ECE/TRANS/WP.29/GRE/2008/28  
11 July 2008

REGULATION No. 37  
(Filament lamps)

Proposal for Supplement 33 to the 03 series of amendments to Regulation No. 37

Submitted by the expert from India \*/

Sheet P18/5W /1

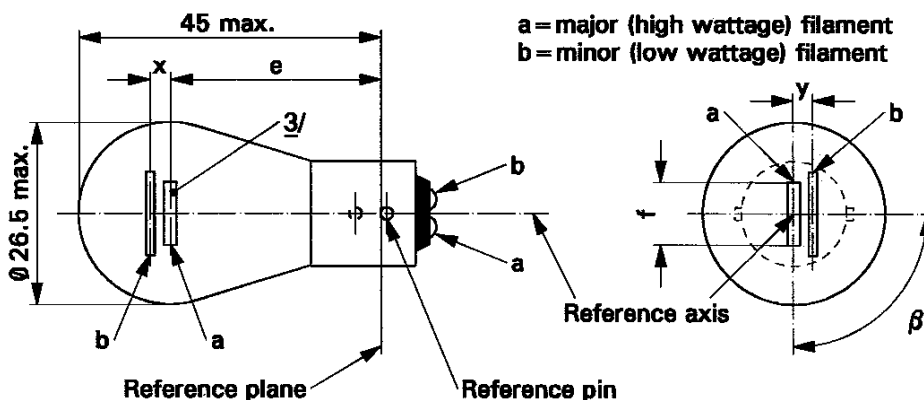
Insert new sheets P18/5W/1 to 3, between sheet P13W/1 to 3 and sheet PR18/5W/1, to read:  
(see next pages).

Dimensions in mm		Filament lamps of normal production			Standard filament lamp			
		min.	nom.	max.				
e	6, 12 V		31.8 <u>1/</u>		31.8 ± 0.3			
	24 V	30.8	31.8	32.8				
f	6, 12 V			7.0	7.0 + 0/- 2			
Lateral deviation <u>2/</u>	6, 12 V			<u>1/</u>	0.3 max.			
	24 V			1.5				
x, y	6, 12 V		<u>1/</u>		2.8 ± 0.3			
x	24 V <u>3/</u>	-1.0	0	1.0				
y	24 V <u>3/</u>	1.8	2.8	3.8				
$\beta$		75°	90°	105°	90° ± 5°			
Cap BAY15d in accordance with IEC Publication 60061 (sheet 7004-11B-7)								
ELECTRICAL AND PHOTOMETRIC CHARACTERISTICS								
Rated values	Volts	6		12		24		12
	Watts	18	5	18	5	18	5	18/5
Test voltage	Volts	6.75		13.5		28.0		13.5
Objective values	Watts	24.5 max.	6.6 max.	23.5 max.	6.6 max.	26.7 max.	11 max.	23.5 and 6.6 max.
	Luminous flux	325	35	325	35	325	40	
	± %	15	20	15	20	15	20	
Reference luminous flux: 325 and 35 lm at approximately 13.5 V

Sheet P18/5W /2

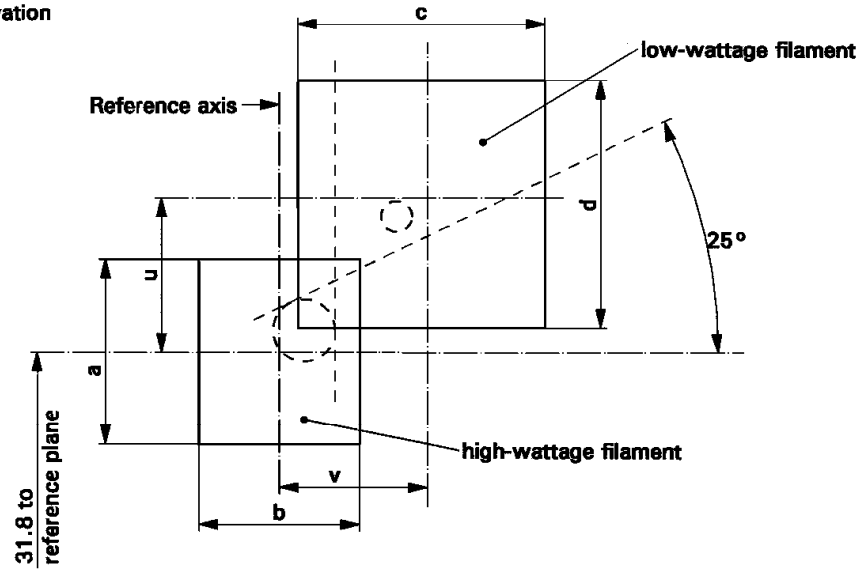
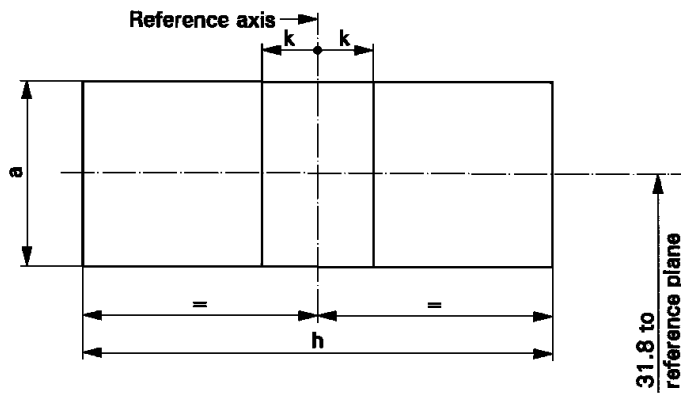
- (a) the major (high wattage) filament is correctly positioned relative to the reference axis and reference plane and has an axis perpendicular, within  $\pm 15^\circ$ , to the plane through the centres of the pins and the reference axis; and whether
- (b) the minor (low wattage) filament is correctly positioned relative to the major (high wattage) filament, whether a filament lamp complies with the requirements.

1. The filament lamp is placed in a holder capable of being rotated about its axis and having either a calibrated scale or fixed stops corresponding to the angular displacement tolerance limits. (i.e.  $15^\circ$ ). The holder is then so rotated that an end view of the major filament is seen on the screen on which the image of the filament is projected. The end view of that filament shall be obtained within the angular displacement tolerance limits.

- 2.1. the projection of the major filament shall lie entirely within a rectangle of height "a" and width "b", having its centre at the theoretical position of the centre of the filament;

- 2.2. the projection of the minor filament shall lie entirely:
    - 2.2.1. within a rectangle of width "c" and height "d" having its centre at a distance "v" to the right of and at a distance "u" above the theoretical position of the centre of the major filament;

- 3.1. the projection of the major filament shall lie entirely within a rectangle of height "a" and width "h", centred on the theoretical position of the centre of the filament;

- 3.2. the centre of the major filament shall not be offset by more than distance "k" from the reference axis.
  - 3.3. the centre of the minor filament axis shall not be offset from the reference axis by more than  $\pm 2$  mm ( $\pm 0.4$  mm for standard filament lamps).

Sheet PR18/5W/1

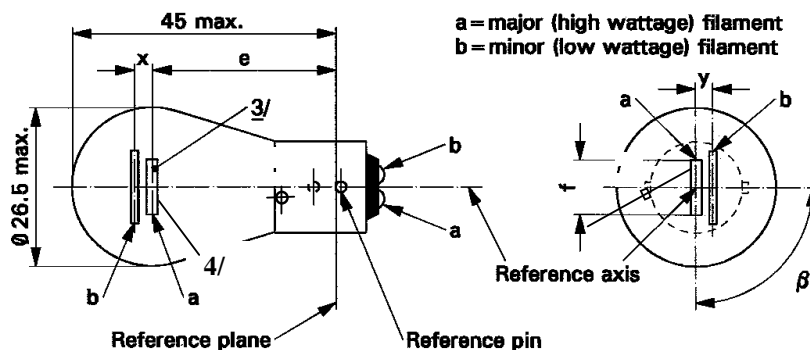
Insert a new sheet PR18/5W/1, between sheet P18/5W/1 to 3 and sheet P19W/1 to 3, to read:

Dimensions in mm		Filament lamps of normal production <u>4/</u>			Standard filament lamp
		min.	nom.	max.	<u>5/</u>
e	12 V		31.8 <u>1/</u>		31.8 ± 0.3
	24 V	30.8	31.8	32.8	
f	12 V			7.0	7.0 + 0/- 2
Lateral deviation <u>2/</u>	12 V			<u>1/</u>	0.3 max.
	24 V			1.5	
x, y	12 V		<u>1/</u>		2.8 ± 0.3
x	24 V <u>3/</u>	-1.0	0	1.0	
y	24 V <u>3/</u>	1.8	2.8	3.8	
β		75°	90°	105°	90° ± 5°

" **CATEGORY W10W** **Sheet W10W/1**

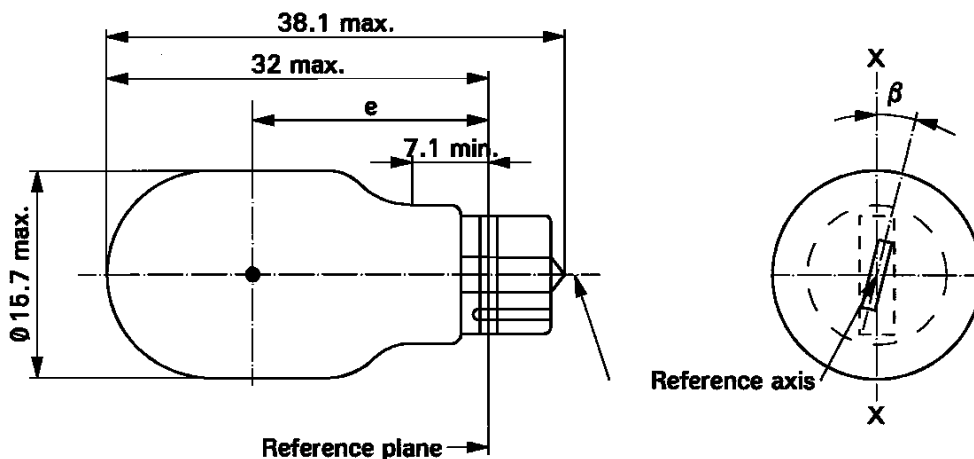
Insert a new sheet W10W/1, between sheet W5W/1 and sheet W16W/1, to read:

Dimensions in mm		Filament lamps of normal production			Standard filament lamp
		min.	nom.	max.	
e		18.3	20.6	22.9	20.6 ± 0.3
Lateral deviation	<u>1/</u>			1.0	0.5 max.
β		-15°	0°	+ 15°	0° ± 5°
Cap W2.1x9.5d in accordance with IEC Publication 60061 (sheet 7004-91-3)					
<b>ELECTRICAL AND PHOTOMETRIC CHARACTERISTICS</b>					
Rated values	Volts	12			12
	Watts	10			10
Test voltage	Volts	13.5			13.5
Objective values	Watts	11 max.			11 max.
	Luminous flux	125 ± 20 %			
Reference luminous flux: 125 lm at approximately 13.5 V
